Access Compliance Report

Public Rights-of-Way

(Pedestrian Signals)

Intersection ID: N/A	Main Street:	Cross Street: N/A	Location: N/A
ADA ID: D8A6FC377802	Signal Type: Two Push Buttons-APS	Overall Compliance: No	Severity Score: BTN 1:N/A BTN 2: N/A No BTN: N/A
Codes/Mitigation Info/Possible Solution		Field Measurements/Component Compliance

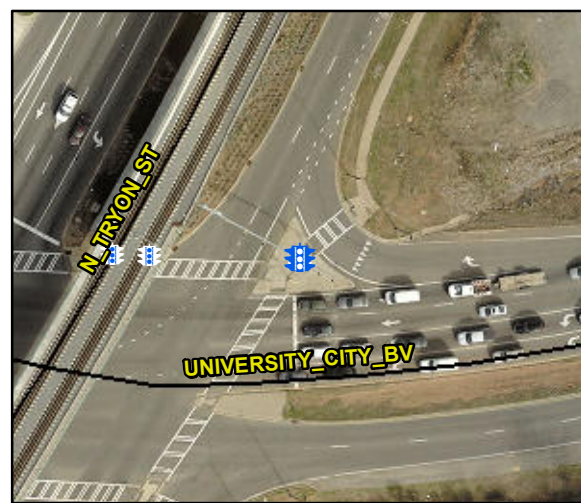
Surveyor Notes: TEXT HT 5/16

PROW/ADA: R410.6, TMUTCD 4e.08, R406.2, R404.7.3, , R209.1

Yes	B 1 Clear Xing Direction?	ClearlyMarked	Yes	B 2 Clear Xing Direction?	ClearlyMarked
	B 1 Crossing Direction	To W		B 2 Crossing Direction	To SW
Yes	B 1 DistanceTo XWalk (in)	0.0	Yes	B 2 DistanceTo XWalk (in)	0.0
No	B 1 DistanceTo Curb (in)	184.0	No	B 2 DistanceTo Curb (in)	82.0
Yes	B 1 Diameter (in)	2.0	Yes	B 2 Diameter (in)	2.0

Possible Solutions: Replace Signal Push Button With APS Button on New Post. Remove & Replace Sign.
